DEVELOPMENT ASSESSMENT REPORT	
Application No.	DA/2020/0486
Address	54 Ferris Street ANNANDALE NSW 2038
Proposal	Garage with Studio
Date of Lodgement	25 June 2020
Applicant	Mr Andrew Colangelo
Owner	Mr Andrew Colangelo Mrs Marie L Colangelo
Number of Submissions	Two (2)
Value of works	\$2,000,000.00
Reason for determination at Planning Panel	Clause 4.6 variation exceeds 10%
Main Issues	<ul style="list-style-type: none"> • Non-compliance with the maximum floor space ratio per Clause 4.4 of the LLEP 2013 • Neighbouring amenity impacts (Solar Access) • Flooding • Parking
Recommendation	Refusal
Attachment A	Reasons for refusal
Attachment B	Without Prejudice Conditions (if not refused)
Attachment C	Plans of proposed development
Attachment D	Clause 4.6 Exception to Development Standards

1. Executive Summary

Existing and Proposed Shadows
11.00am & 12.00pm June 21st
54 Ferris Street Annandale
For: Andrew and Marie Colangelo
Ph: 0414-381148
Date 05/10/2020
Scale: 1/100 Dr No 341/02/2020
Design and Documentation
A.D.Practique www.practique.com.au
297 Concord Road, Concord West
Ph: 0419253653

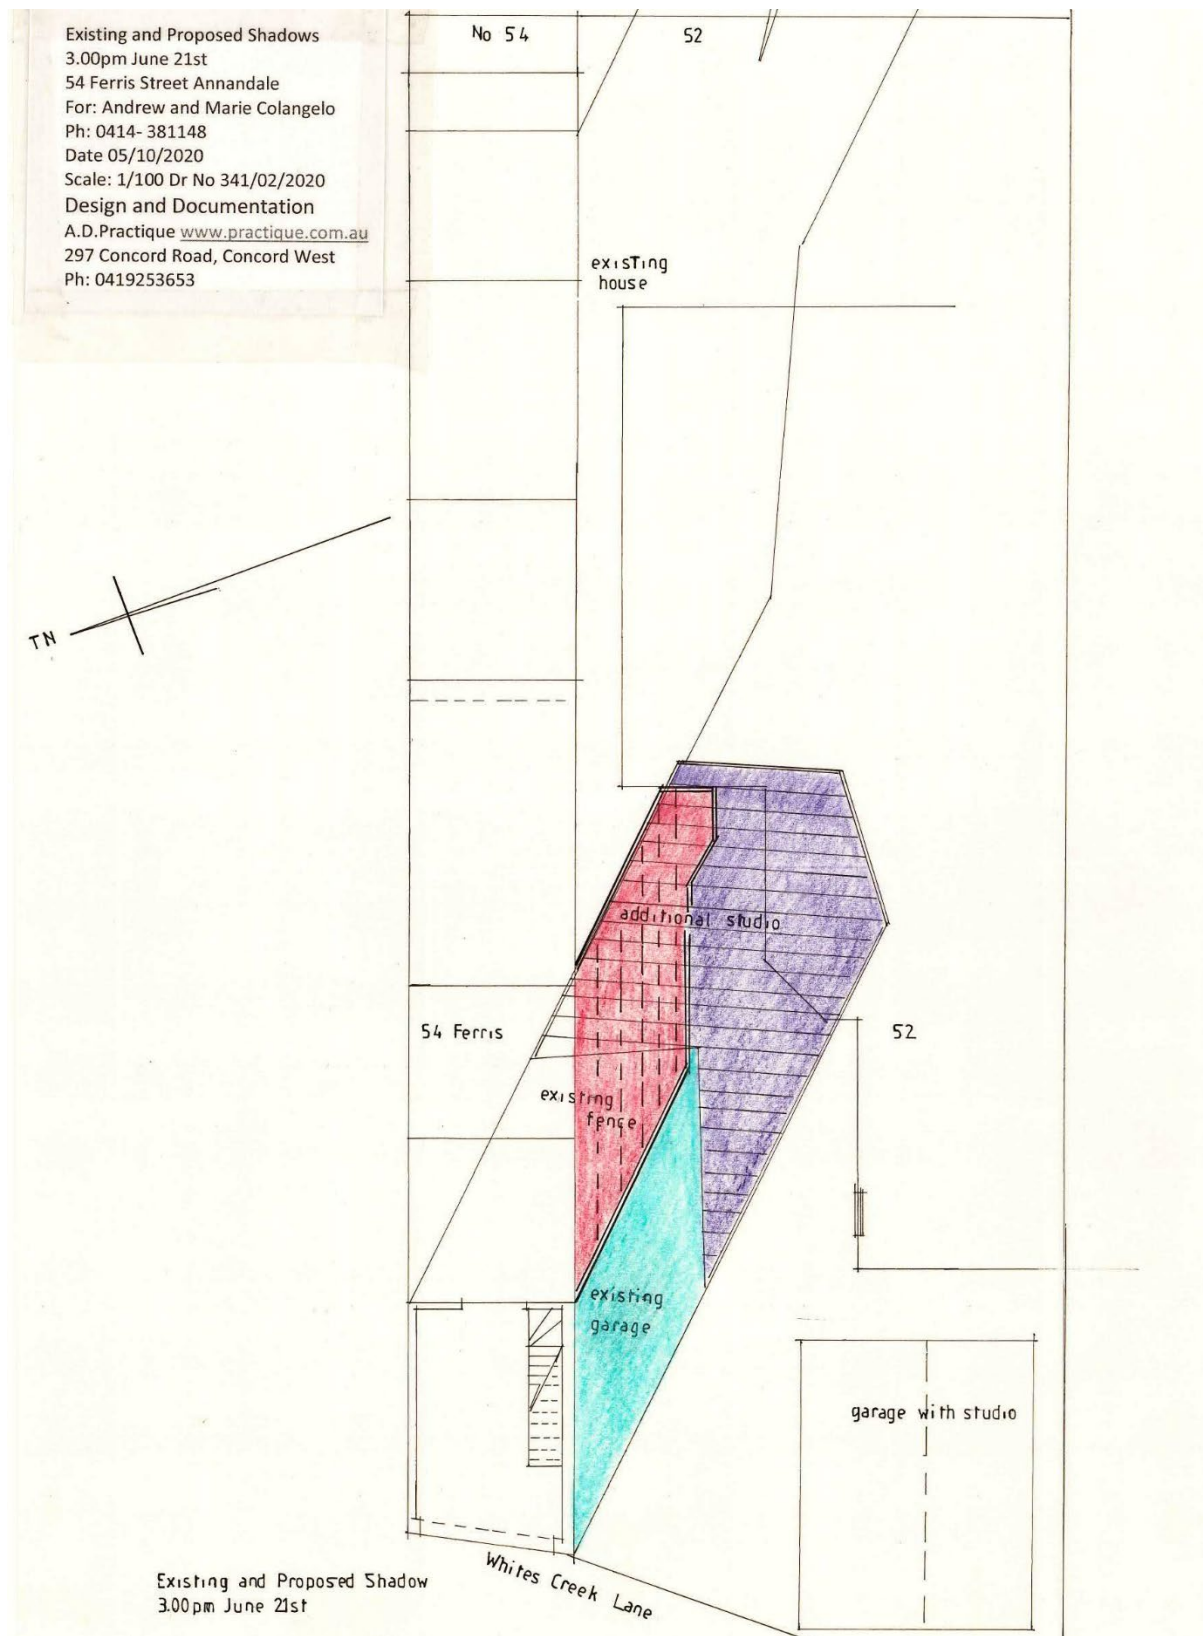
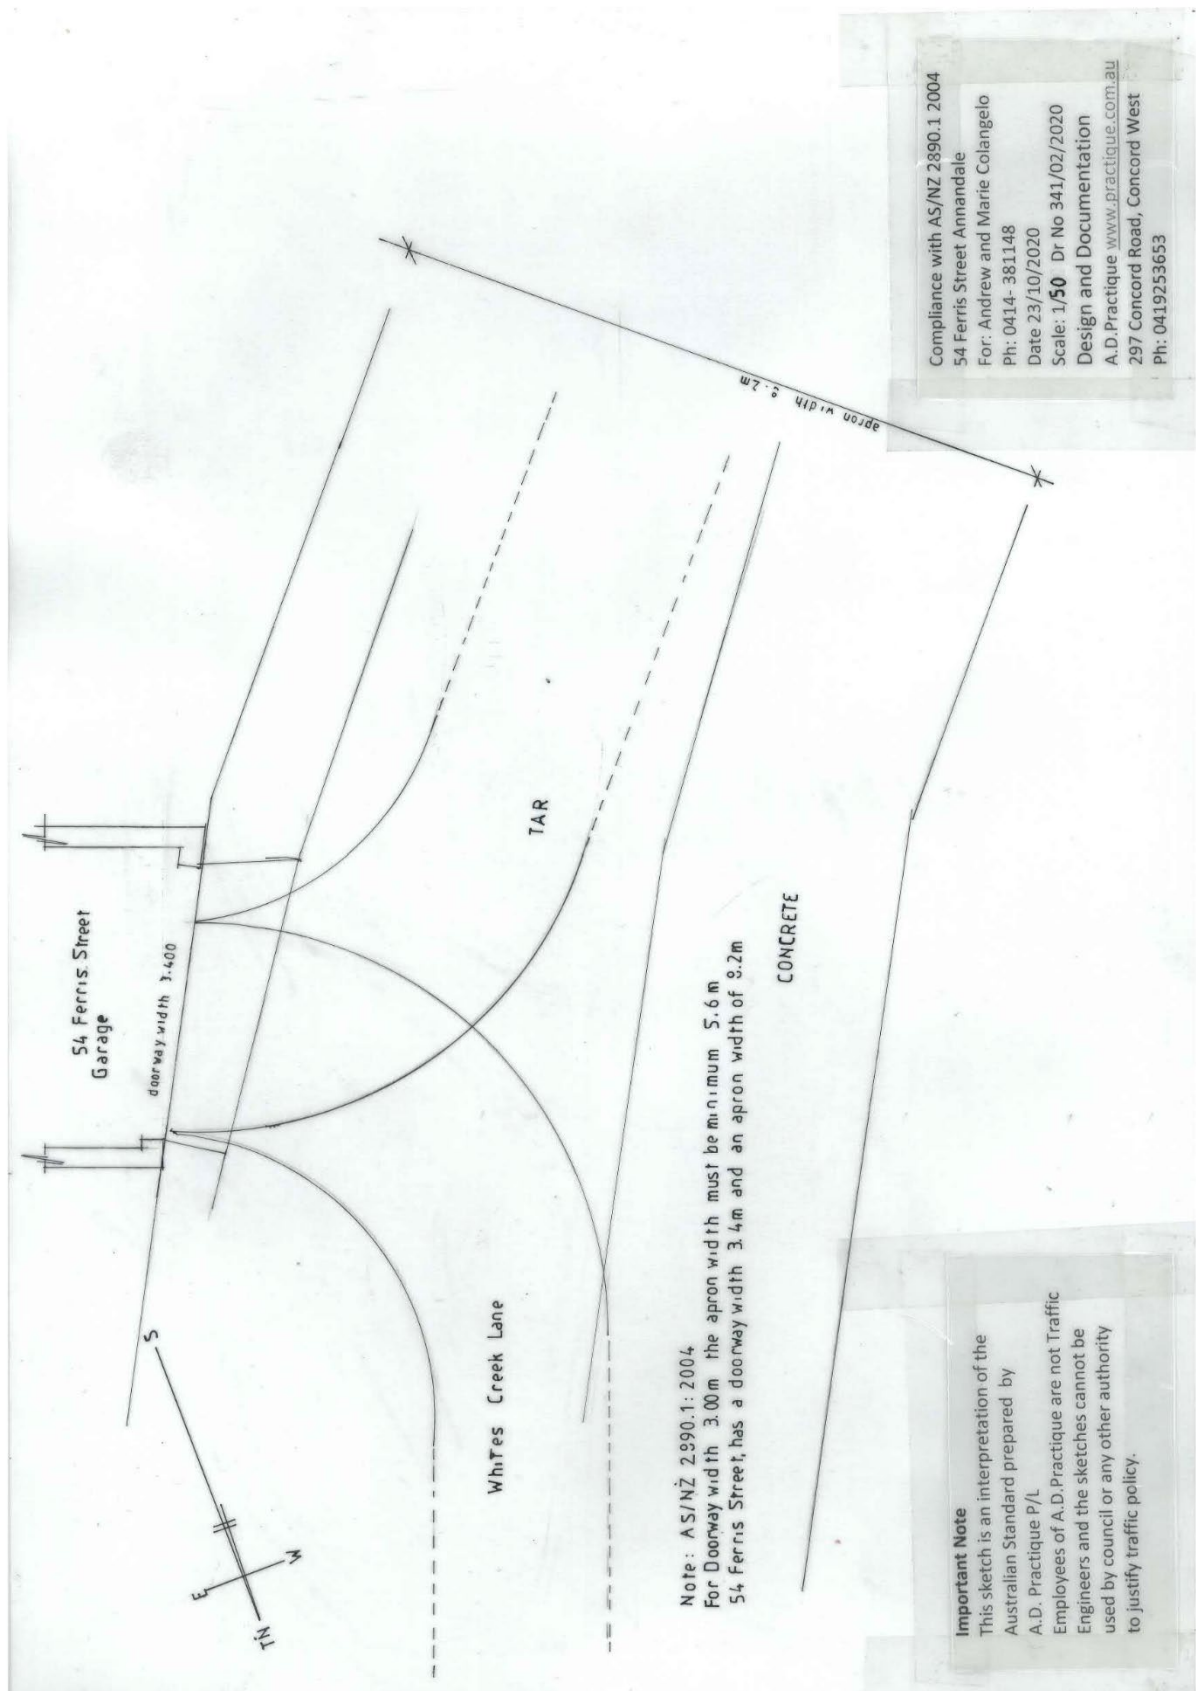
<p>3. Solar Access and Overshadowing</p> <p>The proposal will result in additional overshadowing to the private open space of adjoining properties to the south, in particular No.52 Ferris Street.</p> <p>It is noted that this adjoining property currently does not receive the minimum solar access requirements as prescribed in Clause C3.9 of the Leichhardt Development Control Plan 2013 (LDCP2013). As such, further works are required to minimise (or preferably eliminate) additional overshadowing to the adjoining properties created from this proposal.</p> <p>Given the extent of the FSR variation, the proposal is to be amended to provide either a garage or a studio which employs minimal floor to ceiling heights.</p>	<p>Response to Item 3: Solar Access and Overshadowing</p> <p>Appraisal of Shadow Drawings</p> <p>Reference: Appendix A: Impact on 52 Ferris Street Annandale</p> <p>21st June, 9.00am and 10.00am An appraisal of the shadow drawings would suggest at 9.00am and 10.00am on June 21st the open areas at the rear of No 52 are already in shadow from the elevated fence and the existing garage. Any additional shadowing falls over the existing two storey garage which has no side windows facing north.</p> <p>21st June, 11.00am and 12.00pm At 11.00am and 12.00pm the shadows are moving towards the south-east. There is already significant overshadowing from the existing garage and elevated fence. At eleven am there is impact from the proposed studio and the same applies for 12.00pm. However, there are also similar areas that have no impact from the additional or existing overshadowing.</p> <p>21st June, 1.00pm and 2.00pm At 1.00pm and 2.00pm the angle of the shadow moves further south-east. There is less impact from the existing garage and fence and some impact from the studio. However, at 1.00pm and 2.00pm there are areas of no impact outside the living areas of the house and furthermore there are larger areas opening on the north western side of the garden where there is no impact from overshadowing.</p> <p>21st June, 3.00pm At 3.00pm the angle of the shadow is directly south-east. There is still impact from the existing garage and elevated fence. There is late afternoon shadowing of a small section of the house and the open areas in this section of the house. At the rear of no 52 Ferris there is a significant open area that has no impact from overshadowing.</p> <p>Impact to Solar Access to No.52 Ferris Street Private Open Space There is no impact on No 52 Ferris Street from overshadowing either before or after the proposed development.</p> <p>The shadow drawings show the shadows on the winter solstice</p>

- 1) Using June 21st to determine the impact of overshadowing is misleading of the overall impact. If shadow drawings were produced a month either side of June 21st they would show the shadows had decreased significantly. The impact three months either side of June 21st, (September 21st and March 21st) once more would present a totally different picture of the overall impact of overshadowing. There are 365 days in a year but some reason we are using the shortest, darkest day of the year in terms of the amount of sunlight to determine the viability of a design proposal.

Figure: 5
Proposed garage level

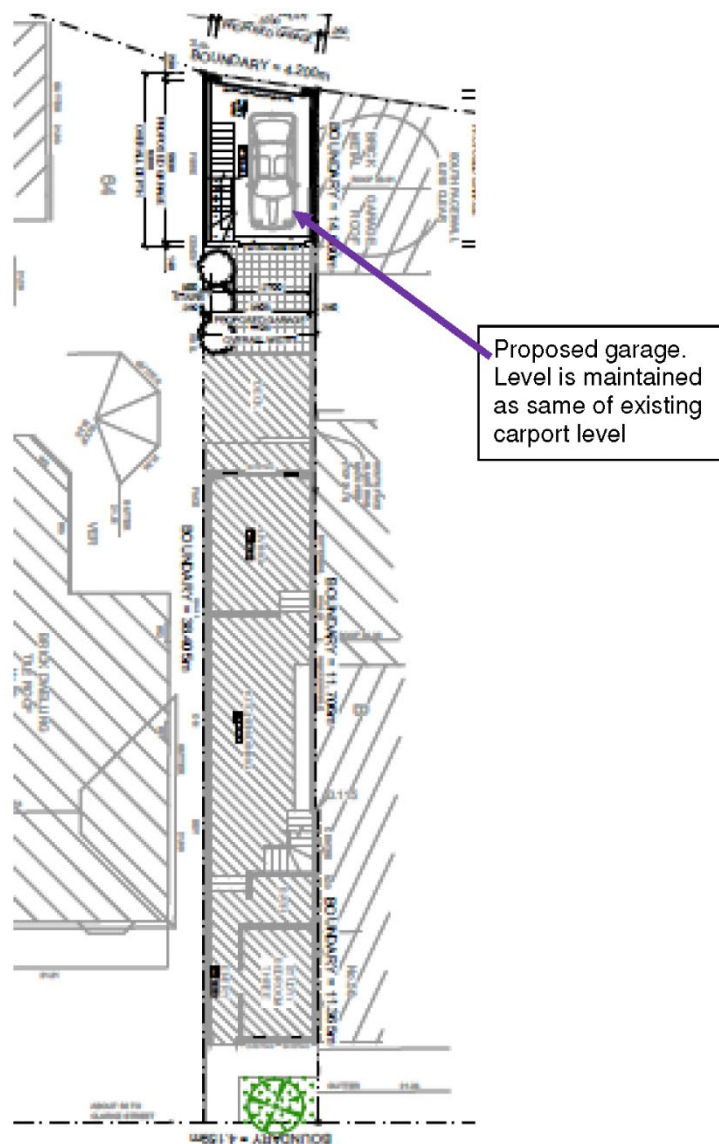
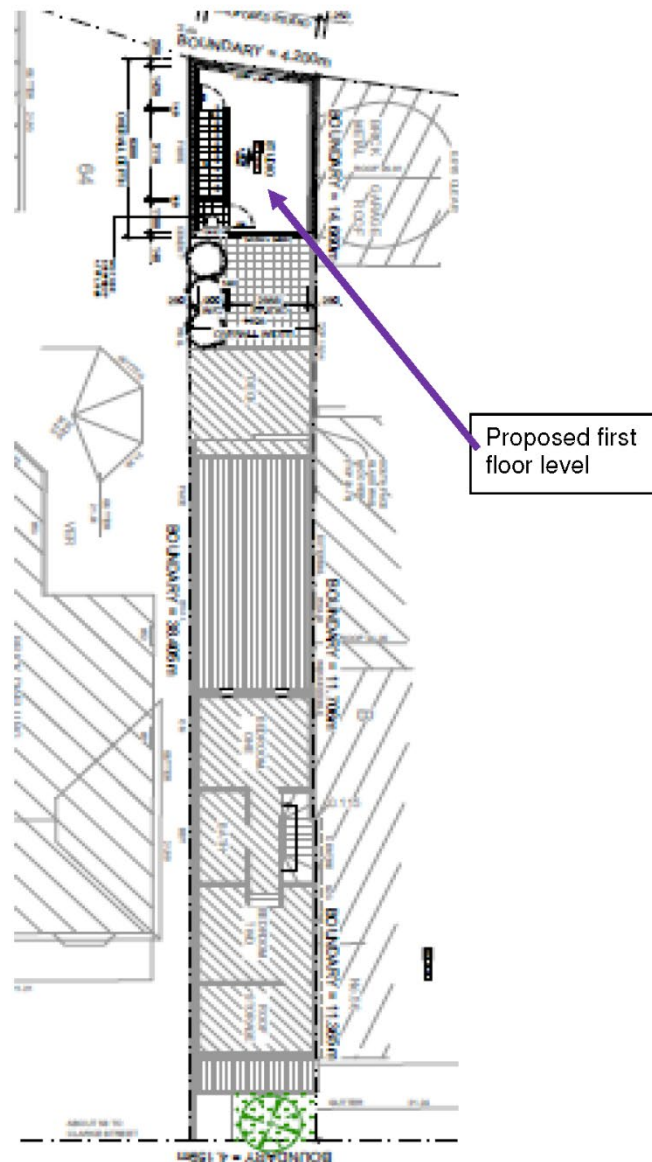
The proposal has not been designed to be at or above the Flood Planning Level. While consideration may be given to a floor level at a lower level, the proposed floor level of 16.47m AHD is considered unacceptable for managing or mitigating flood risk on the site.

The Flood Risk Management Report prepared by HYDRO CIVIL ENGINEERS and dated 23 October 2020 has also failed to demonstrate that providing the floor level at the Flood Planning Level is not practical within the constraints of compliance with Australian Standard AS/NZS 2890.1: Parking facilities.

The approximate locations of development are shown in figure 5 and 6. The flood planning levels required for this development area as follows. As per Council flooding information, the rear section is in 1 in 100 flood level of 17.35m

The proposed level in architectural plan is 16.45m at front gate and 16.85m at end entrance of the garage. 18.50m. These levels are matching existing carport levels. The developer has not raised floor levels. This is satisfying Council and Australian standards.
